**WARRANTY  
BULLETIN**

Wb07-08

DATE : AUGUST 2007	SECTION : 06 - Electrical
EXPIRATION: AUGUST 2009	
SUBJECT : DECAL REPLACEMENT IN THE MAIN POWER COMPARTMENT

**CB11 SHOULD  
INDICATE 50 AMP.**

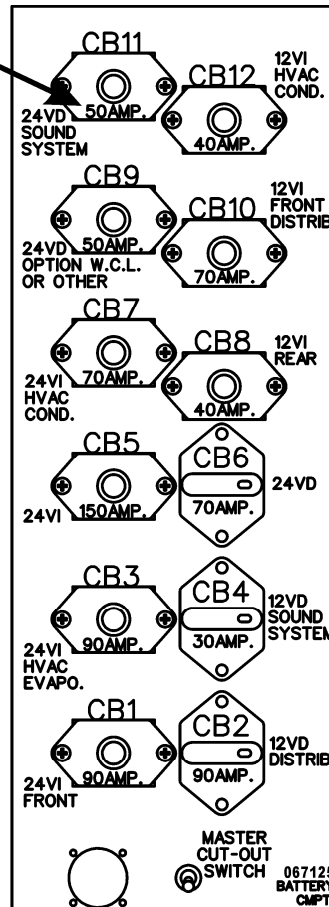
On the above-mentioned vehicles equipped with the new sound system, CB11 amperage was changed from 35A to 50A. It is possible that the wrong rear junction panel decal was installed in the main power compartment; if this is the case, replace the decal.

1. Open main power compartment door in order to locate the decal 066477.
2. Check circuit breaker CB11 amperage, it should indicate 50 AMP.
3. In the case where it indicates 35 AMP. replace the decal with decal 067125 that indicates 50 AMP.
